**GENOA CHARTER TOWNSHIP BOARD**

**April 4, 2016  
Regular Meeting  
6:30 p.m.**

**RE:** **GILDEN WOODS CHILD CARE - LIVINGSTON COMMONS PHASE 2**  
Environmental Impact Assessment and Final PUD Site Plan

<b>Attention:</b>	Kelly Van Marter, AICP Planning Director and Assistant Township Manager
<b>Subject:</b>	Gilden Woods Day Care – Site Plan Review #2
<b>Location:</b>	Grand Oaks Drive – vacant parcel on northwest side of Grand Oaks, west of Latson Road
<b>Zoning:</b>	NR-PUD Non-Residential Planned Unit Development District

1 EAST ELEVATION  
SCALE: 1/8" = 1'-0"

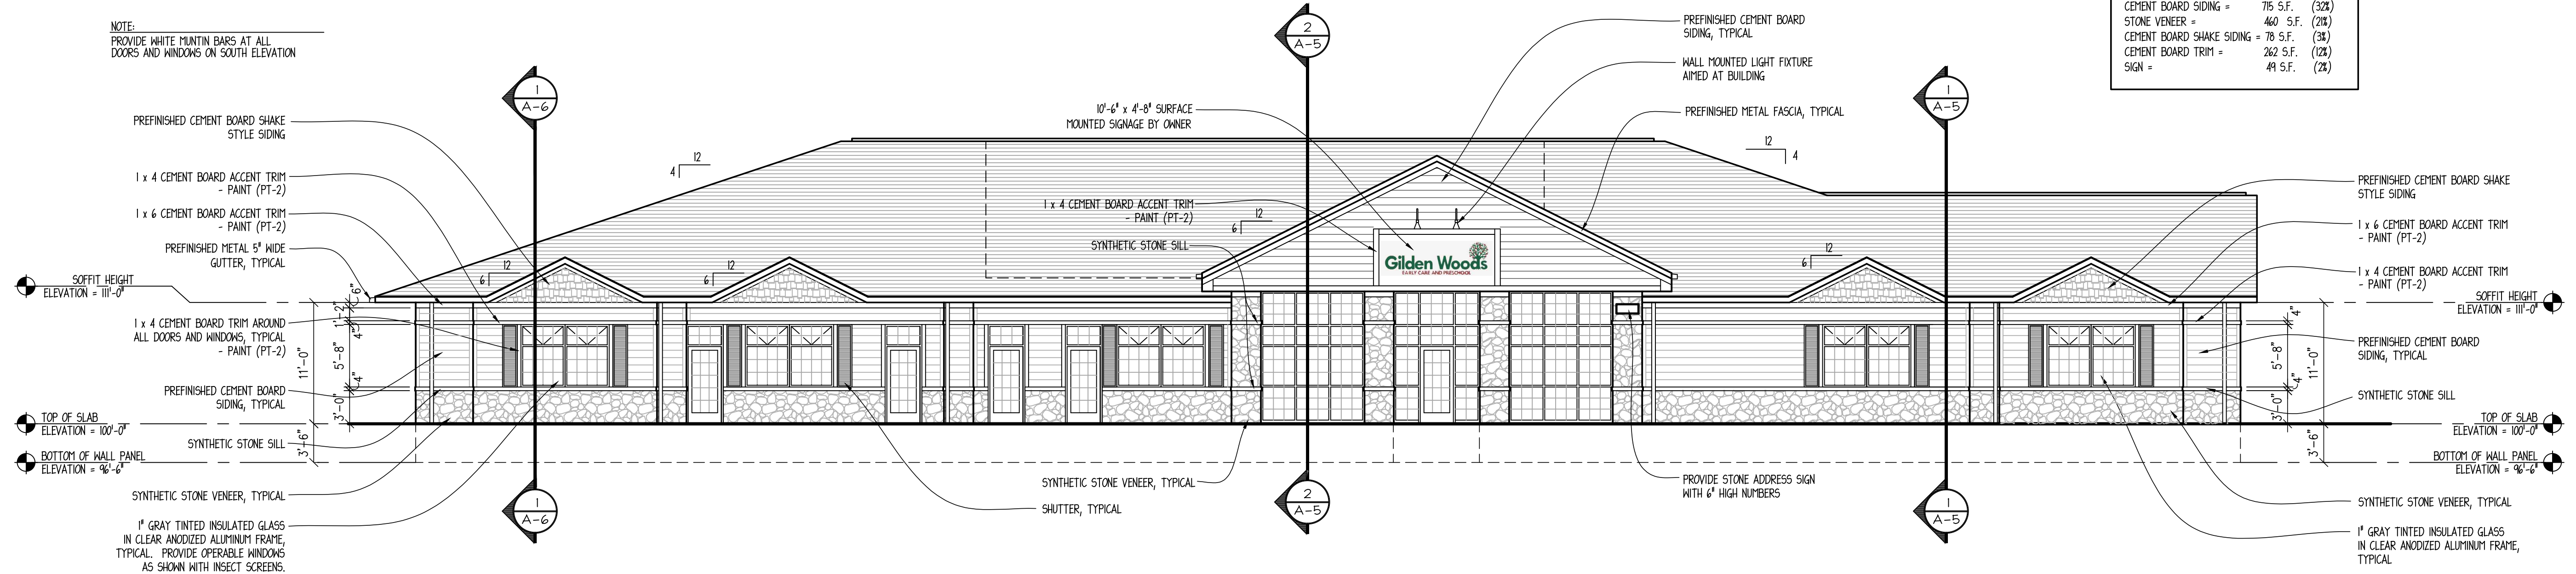
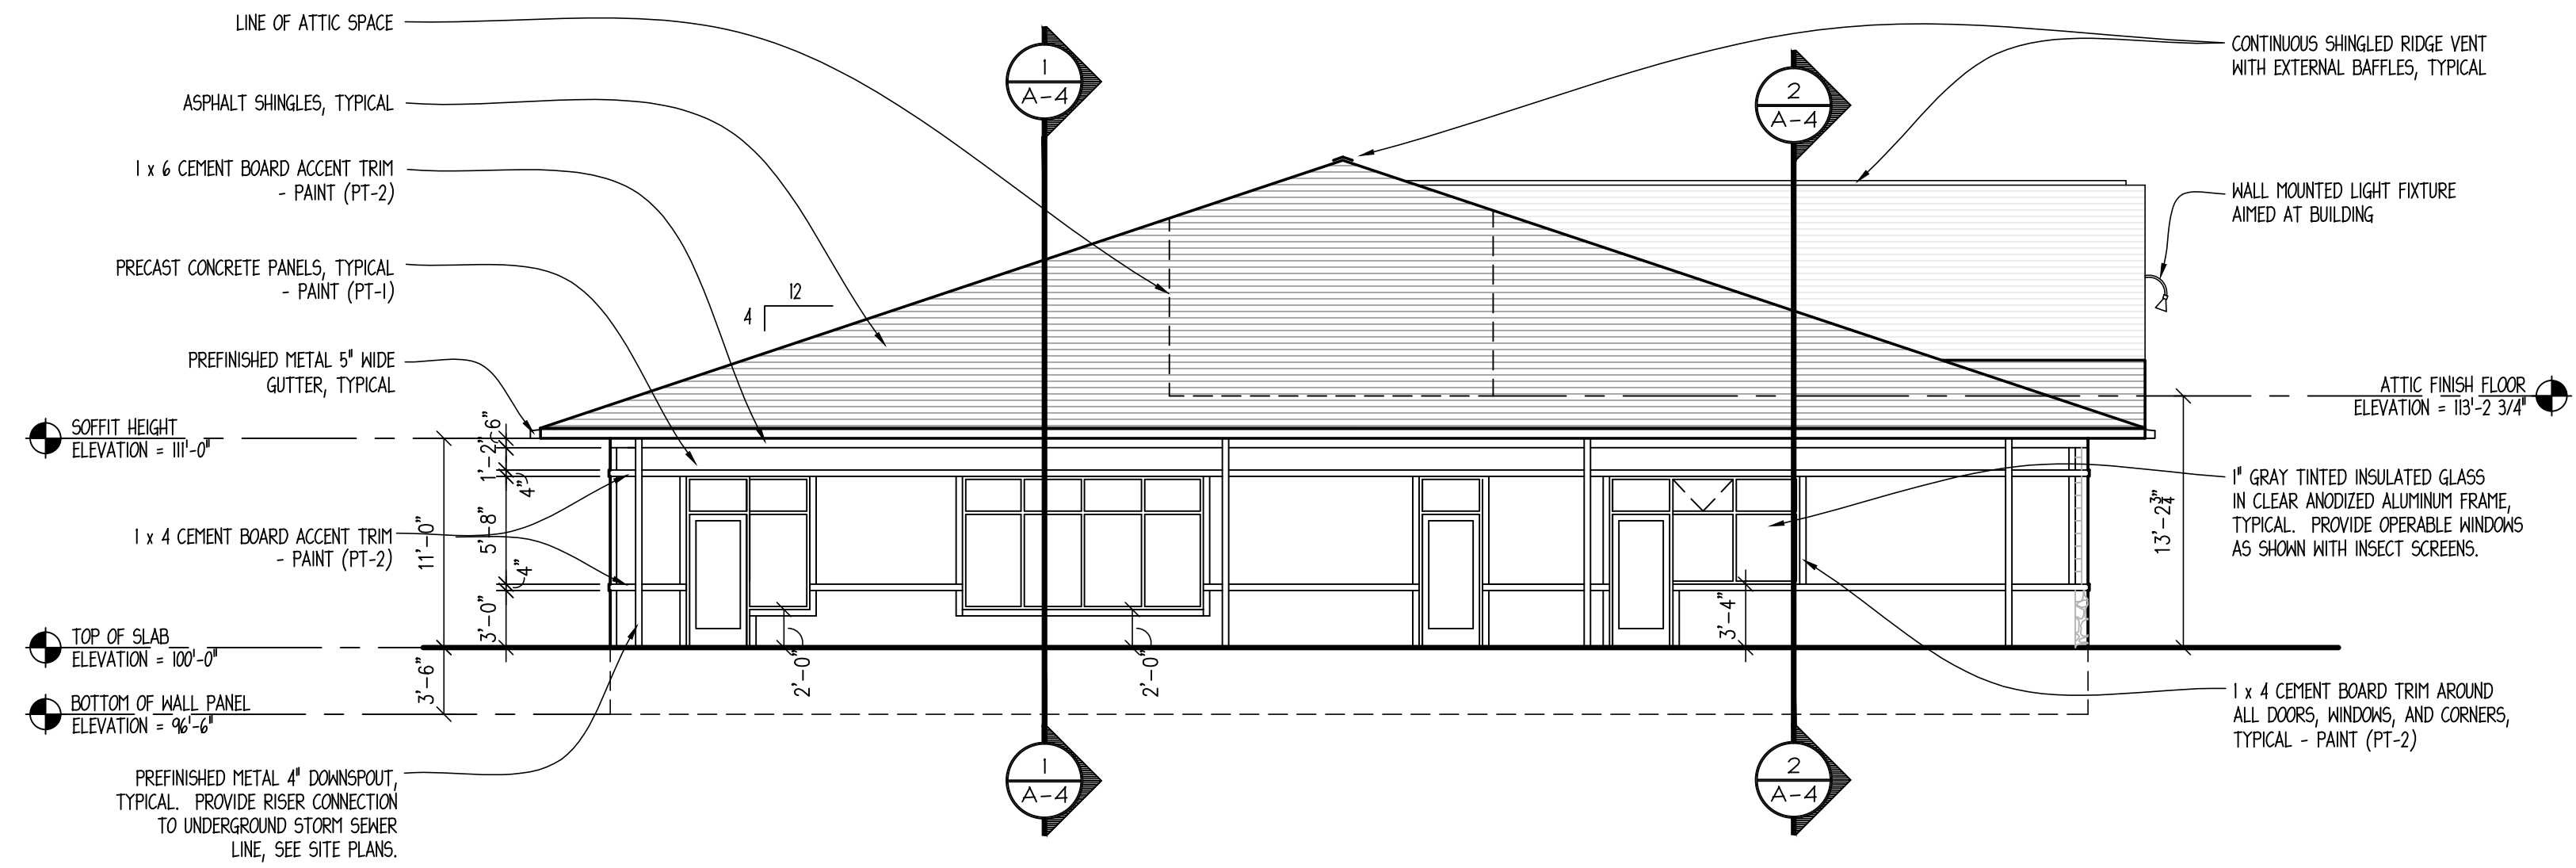
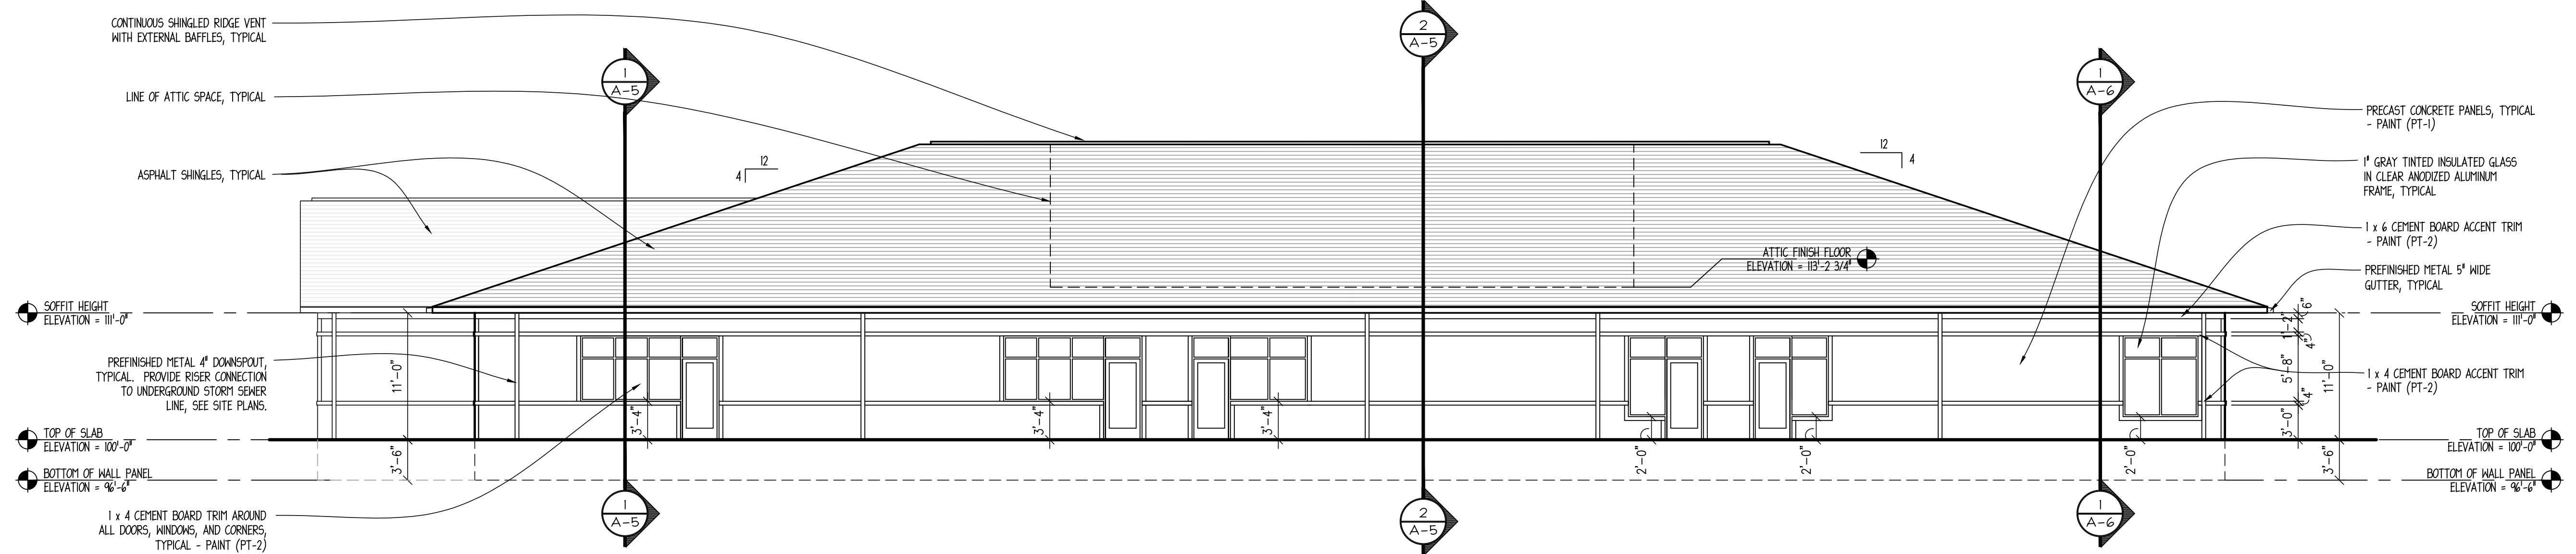
They have added more stone to the building; however, they have not met the 80% requirement for natural materials per the PUD Agreement. Commissioner Rauch likes the proposed building materials; however, he would like to have more stone added to the sides of the building.

Building material calculations have been added to the elevation drawings; however, none of the building sides meets the requirement for 80% natural materials.

Mr. Witte stated he can add stone to the north side of the building and extend the fence on the south side of the building so it will not be seen. The fence is opaque. It was also suggested to carry the lap siding on the north side of the building to match the front. Both Mr. Witte and Mr. Boverhof agreed to this suggestion.

- 1). The proposed southern fence which was previously proposed as chain link has been modified to be a 6 ft solid vinyl fence, which is the same as the remainder of the proposed fencing that will face Grand Oaks Drive.
- 2). The north side elevation of the building has been modified to provide the same stone veneer base and lap siding that is present on the front building elevation.
